EO 55-45-6A

5 Jun 69

LIST OF FIELD MODIFICATIONS
SAFETY HARNESS - GENERAL

Figure 1 (Issue 1)

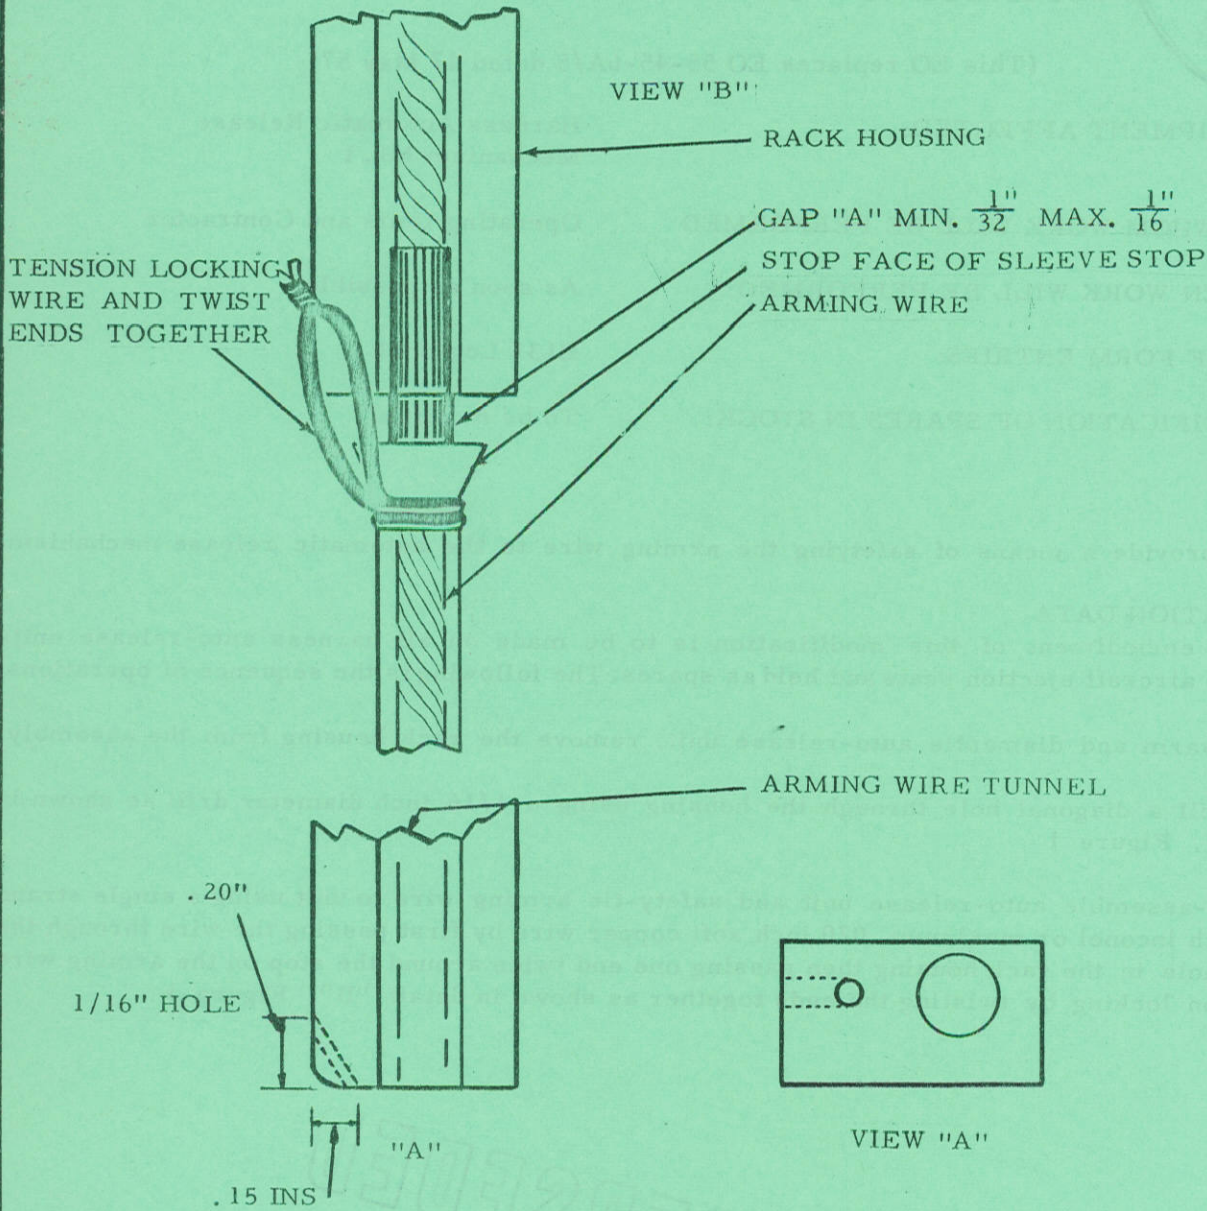
- (a) Disarm and dismantle auto-release unit, remove the rack housing from the assembly.
- (b) Drill a diagonal hole through the housing using a 1/16 inch diameter drill as shown in detail "A", Figure 1
- (c) Re-assemble auto-release unit and safety-tie arming wire to unit using a single strand of .015 inch inconel or maximum .020 inch soft copper wire by first passing the wire through the diagonal hole in the rack housing then passing one end twice around the stop on the arming wire and tension locking by twisting the ends together as shown in detail "B", Figure 1.

USE .015" INCONEL OR
 MAXIMUM .020" SOFT
 COPPER WIRE FOR
 LOCKING PURPOSES.

Figure 1

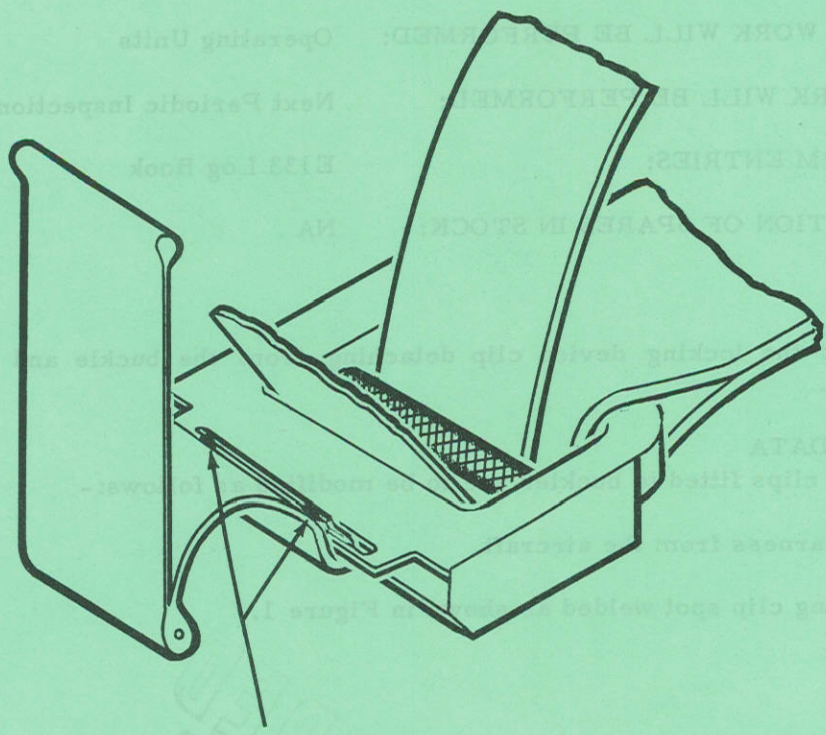
- (a) Remove harness from the aircraft.
- (b) Have spring clip spot welded as shown in Figure 1.

Figure 1

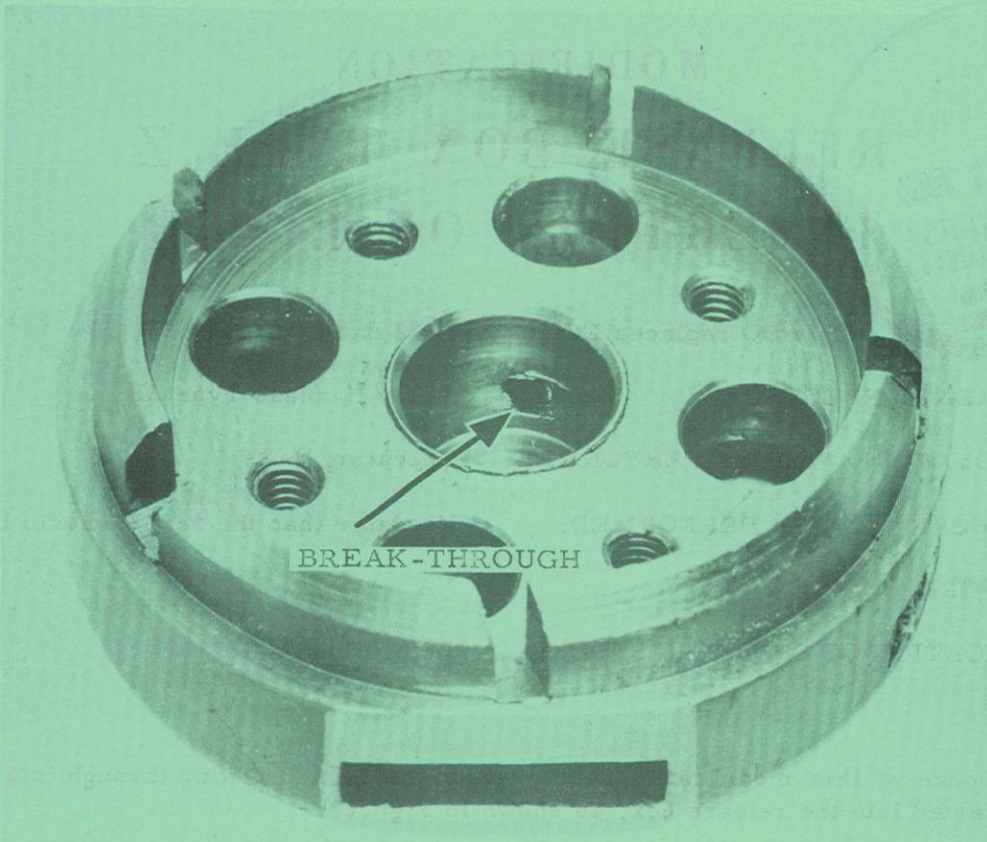
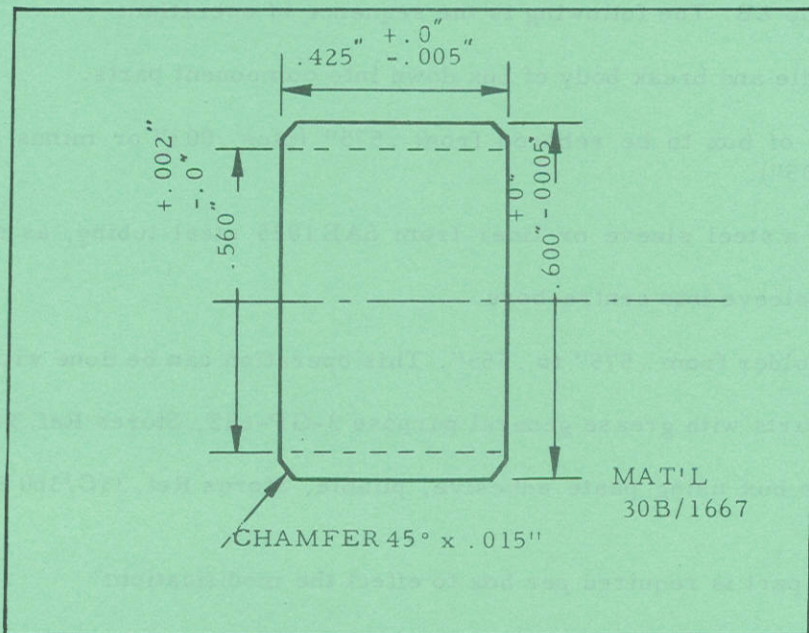
1 The purpose of this modification is to prevent the lugs breaking through into the centre-bore when inserted into the release box, as shown in Figure 1.

- (a) Remove handle and break body of box down into component parts.
- (b) Centre-bore of box to be rebored from .575" (plus .003" or minus .0") to .600" (plus .000" or minus .0005").
- (c) Manufacture a steel sleeve or liner from SAE1025 steel tubing, as shown in Figure 2.
- (d) Press steel sleeve into centre-bore.
- (e) Grind ball-holder from .575" to .555". This operation can be done with a file.
- (f) Grease all parts with grease general purpose 3-GP-682, Stores Ref. 34A/178.
- (g) Re-assemble box using paste adhesive, pliable, Stores Ref. 33C/360 to lock all screws.
